Project: **OAHS Multi-Use Room Building**
Project No. 2-2022-02-22-01
 Orcutt Academy High School
 610 Pinal Ave, Orcutt, CA 93455

BID ADDENDUM 04

ADDENDUM NO. 02

Project: Orcutt Union School District
 Orcutt Academy High School
Multi-Use Room Building
 19six No. 20179.01
 DSA App. No.: 03-121912 File No.: N/A
 Bid No.:

SHEET NO.
A-301
 DATE: APRIL 5, 2022

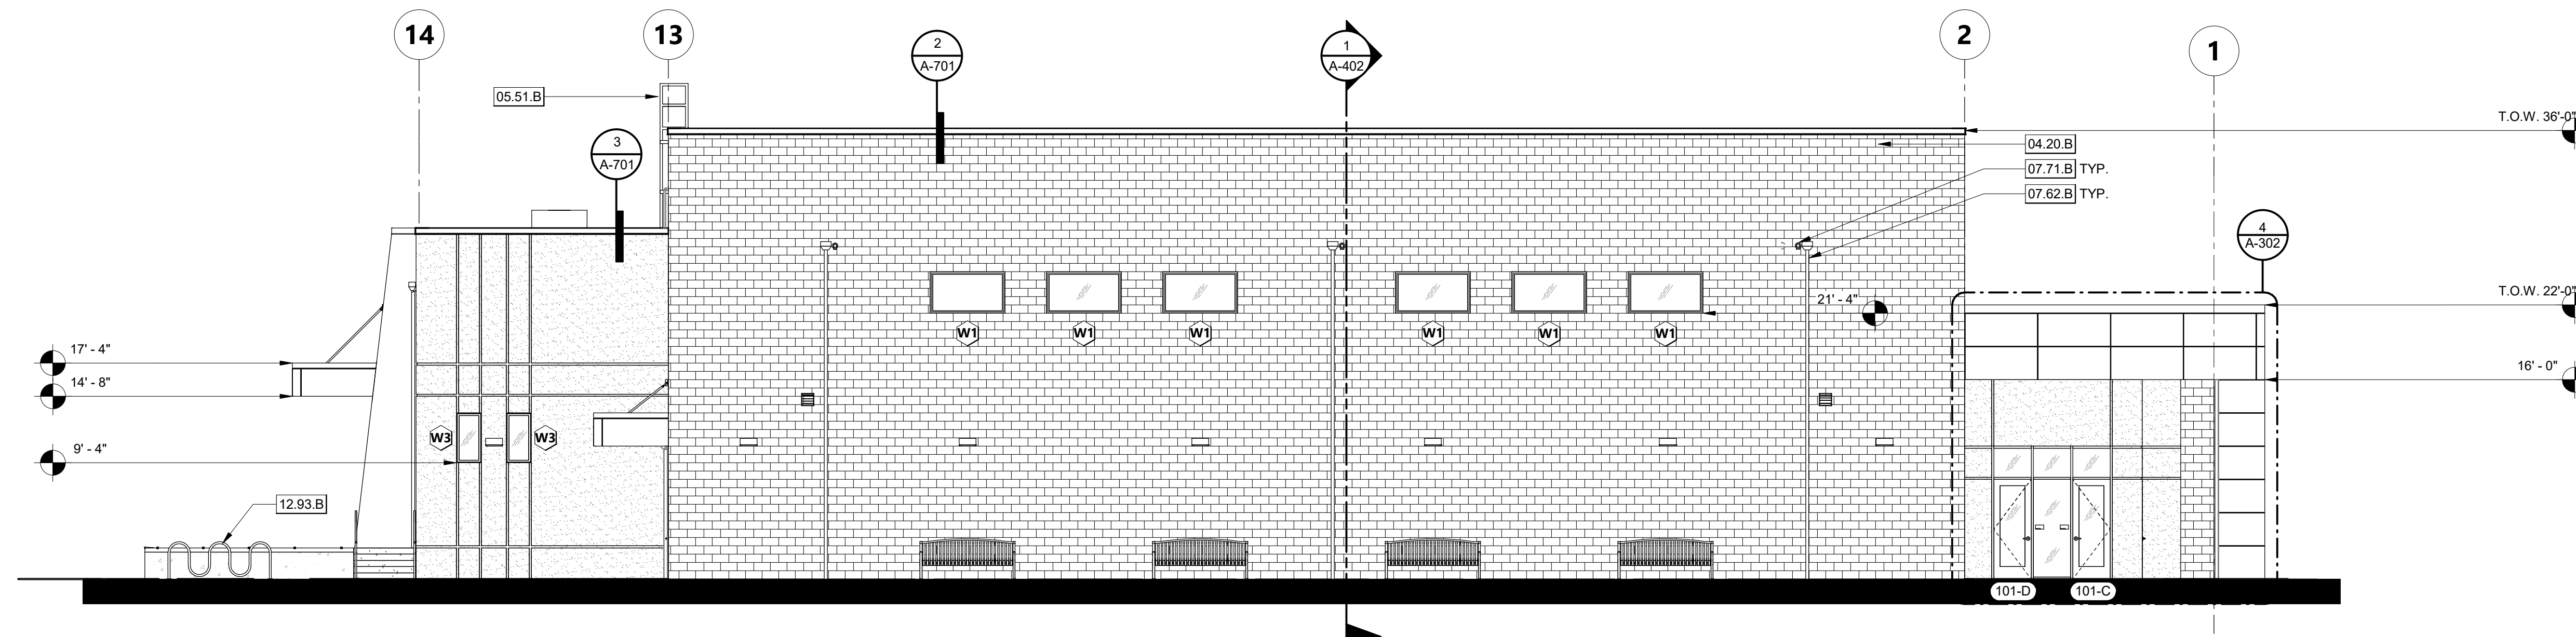
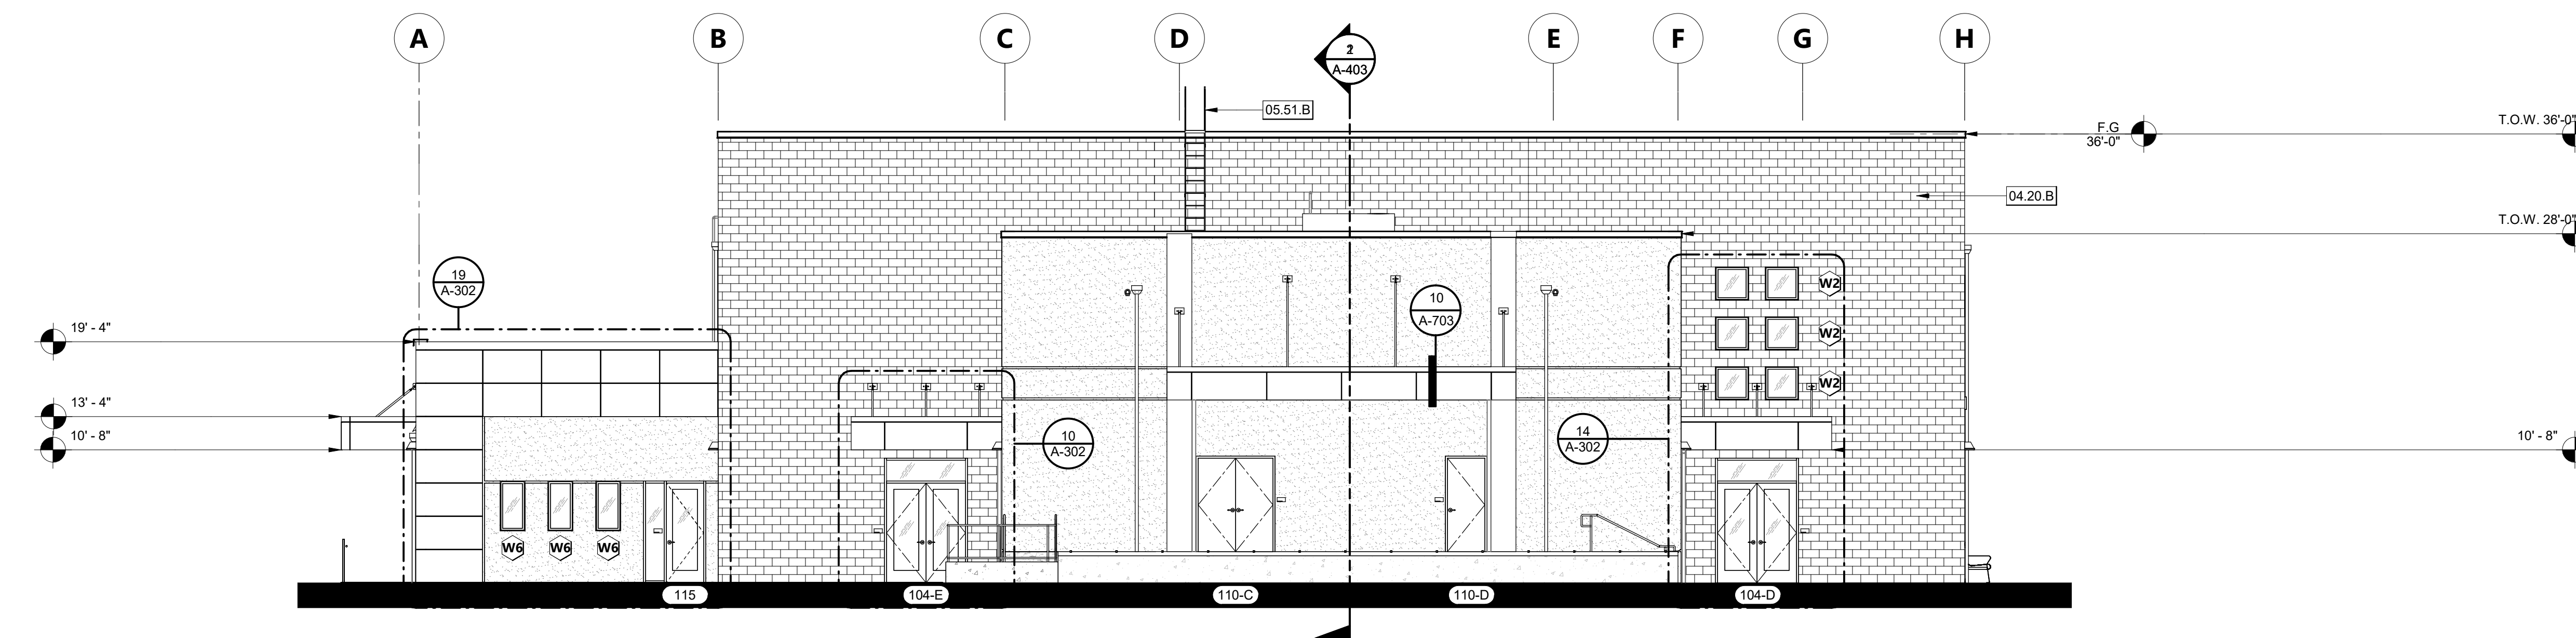
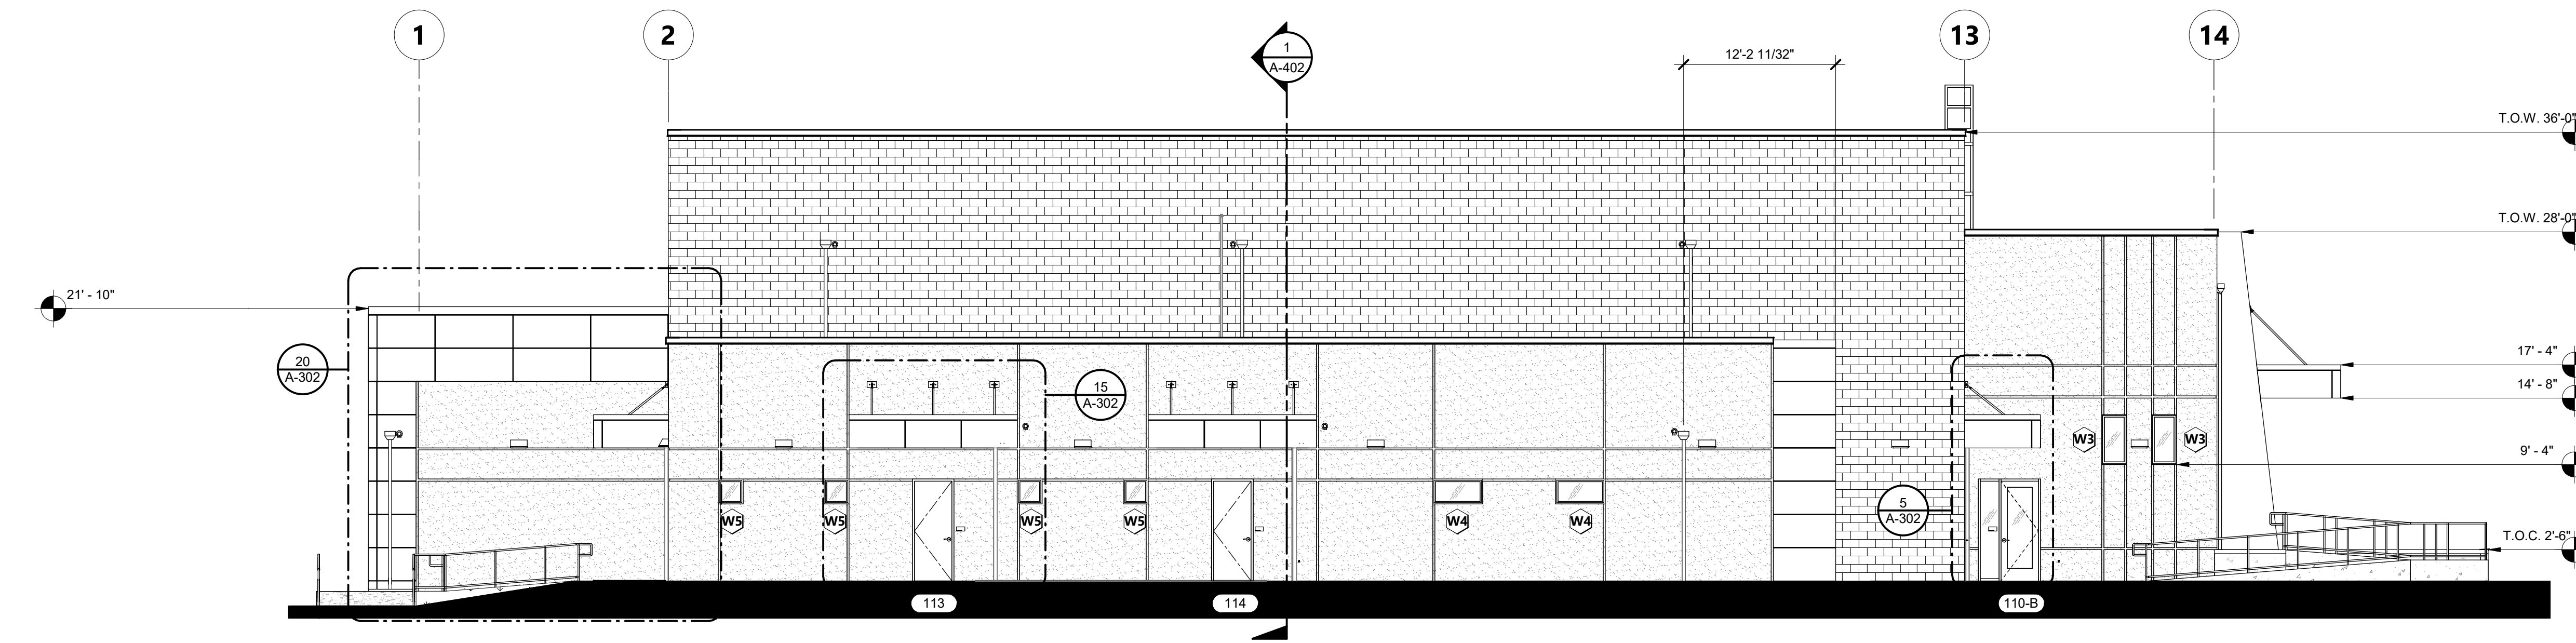
- Item #5:** **Downspouts.** Revise keynote 07.62.B on sheet A-301 to note material type per plumbing specifications. See revised sheet A-301.
- Item #6:** **Board Insulation.** Revise detail 1/A-702 to specify board insulation. See revised sheet A-702.
- Item #7:** **Hose Bibb.** Add hose bibb (HB-1) to Plumbing Fixture Schedule on sheet P001. Provide cutsheet for hose bibb (HB-1). See revised sheet P001. See cutsheet (HB-1).
- Item #8:** **Overflow Nozzle.** Add nozzle and update reference notes on sheet P221. See revised sheet P221.

4.2. Plans show RWLs down exterior of building. Specs call for RWL piping to be No Hub Cast Iron. Sheet A-301 sheet note 07.62.B calls schedule 40. Please advise material type.

- 04.20.B 12" SPLIT FACE CMU
- 05.51.B EXTERIOR ALUMINUM LADDER
- 07.41.A METAL WALL PANELS
- 07.62.B SYSTEM DOWNSPOUT PER PLUMBING SPECIFICATIONS, CONNECT TO STORM DRAIN
- 07.71.B OVERFLOW NOZZLE
- 09.24.A PORTLAND CEMENT PLASTER
- 09.24.C 2" ALUMINUM REVEAL
- 12.93.B BIKE RACK

4.2.1. Response: Revise A-301 keynote 07.62.B to show material type per plumbing specifications (no-hub cast iron). This has been included in Addendum #2.

KEE MEMBRANE ROOFING 1 1/2" = 1'-0" 1

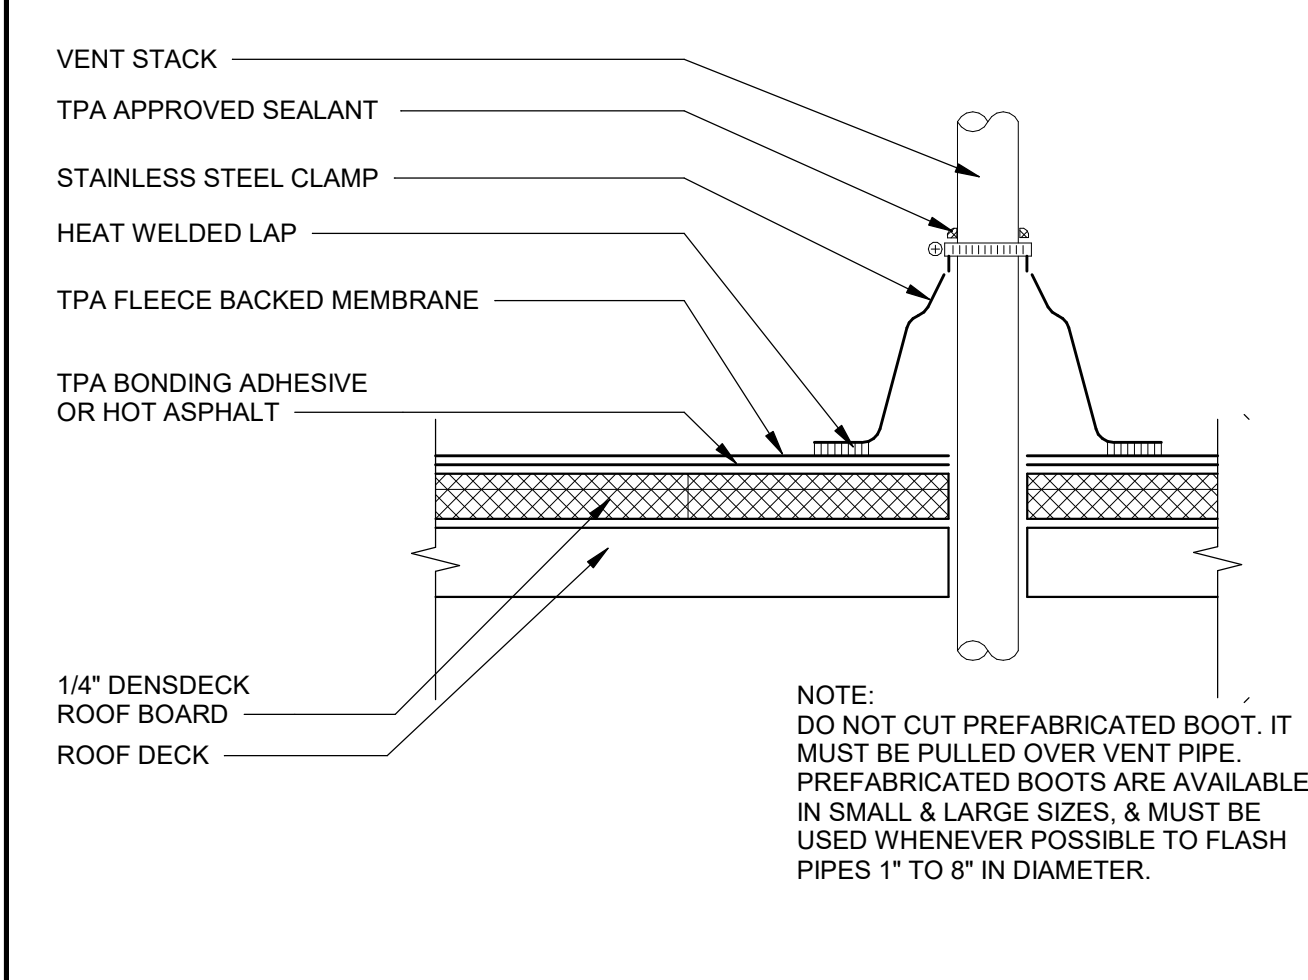
3.1. In the Specs Table of Contents, 07 21 13 Board Insulation is listed. After searching thoroughly, I could not locate the actual spec section in the specs. If you could please provide the specs for 07 21 13 or update the Table of Contents, it would be most appreciated.

3.1.1. Response: Remove specification section 07 21 13 Board Insulation from the Specifications' Table of Contents. Refer to revised detail 1/A-702 from the Bid Set Drawings and specification section 09 24 23 (subsection 2.03) for information on board insulation used. Revised A-702 sheet has been included in Addendum #2.

SHEET NO.
P001

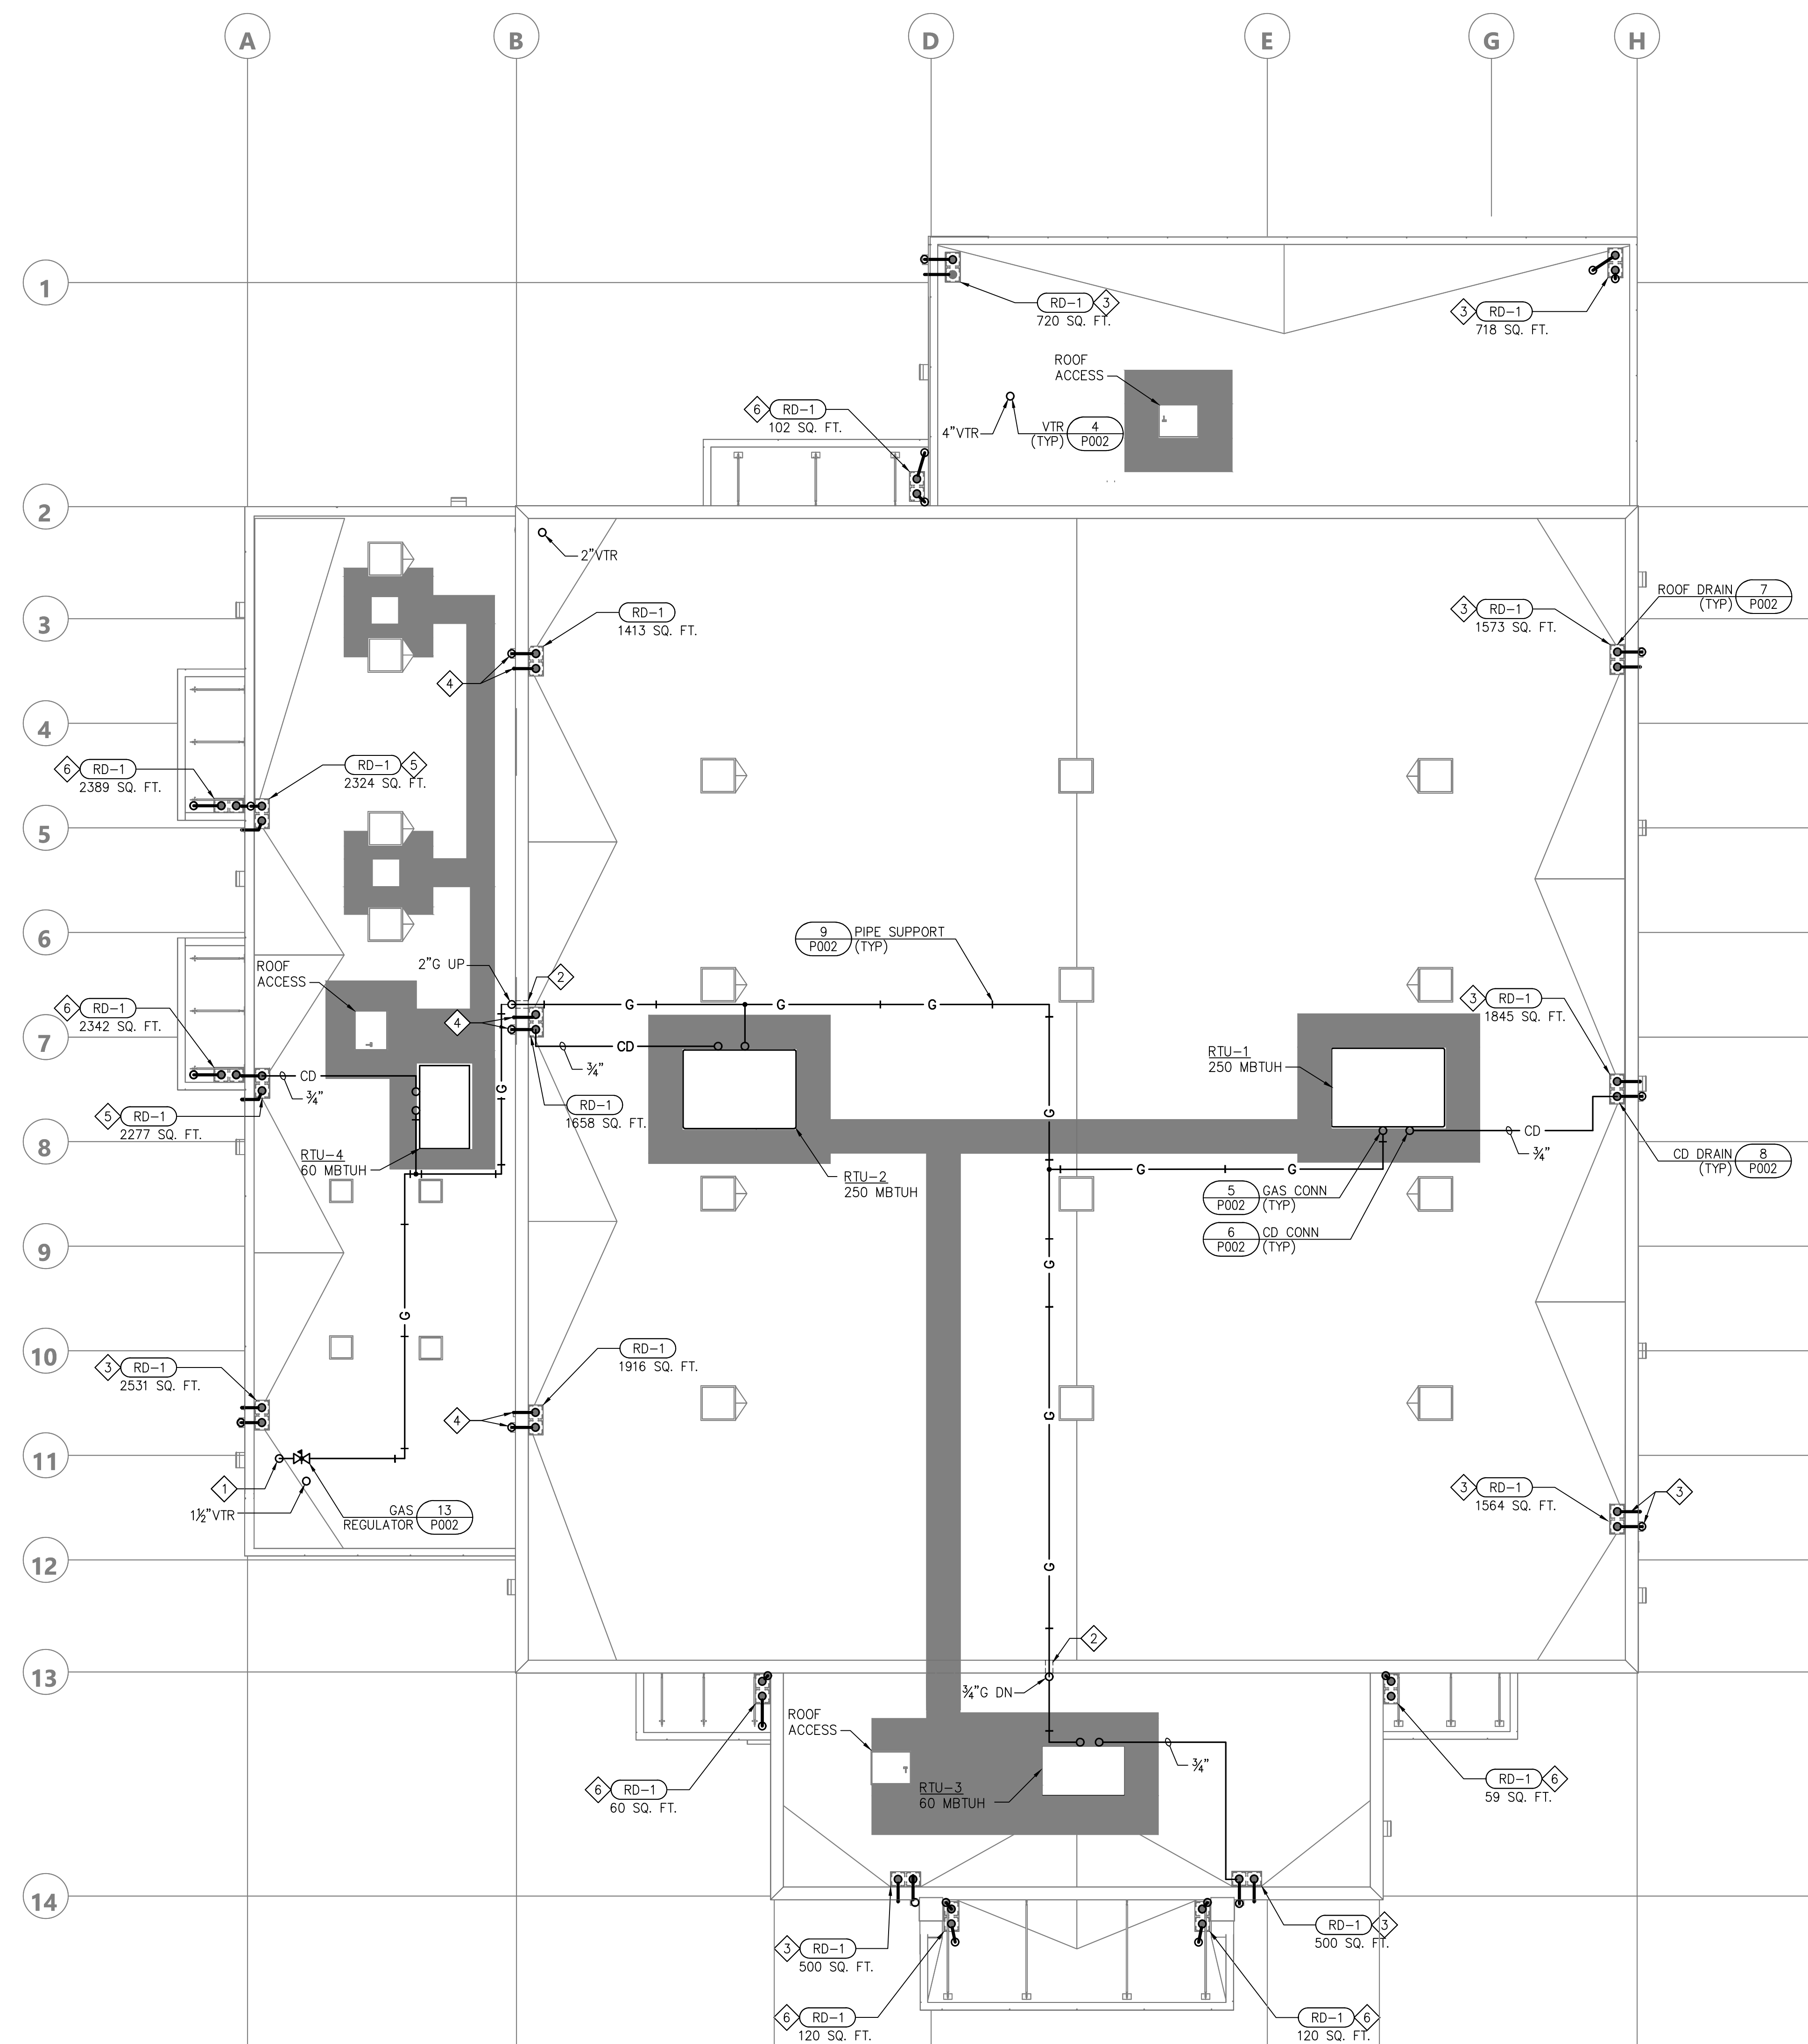
4.1. Sheet P-201, P-501 HB-1 hose bibs no schedule no spec. Please advise on fixture type.

4.1.1. Response: Added spec for hose bibb (HB-1) to sheet P001. See provided cutsheet. Revised sheet and cutsheet has been provided in Addendum #2

SHEET NO.
P221
DATE: MARCH 2, 2022

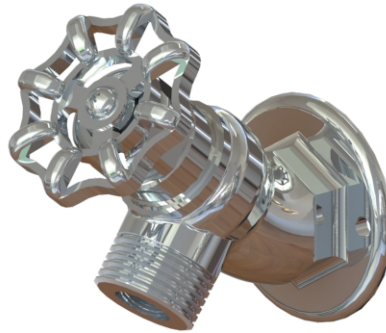
4.3. Sheet P221 sheet note 3 RWO spill to grade. Sheet A-301 sheet note 07.62.B calls overflow nozzle. Please advise if nozzle is required.

- 1 2"MPG from below.
- 2 Gas pipe penetration through parapet wall, see detail 15/P002.
- 3 3"RWL down on exterior wall, RWL to underground storm drain, RWL to overflow nozzle, spill to grade.
- 4 3"RWL on 3"RWL down on exterior wall, spill to lower roof.
- 5 3"RWL spill to lower roof, RWL to overflow nozzle, spill to grade.
- 6 3"RWL down on exterior wall; RWL to underground storm drain, 3"RWL spill to grade from under canopy.

4.3.1. Response: Yes, nozzle is required. Updated Reference notes on Sheet P221. Revised sheet has been included in Addendum #2.
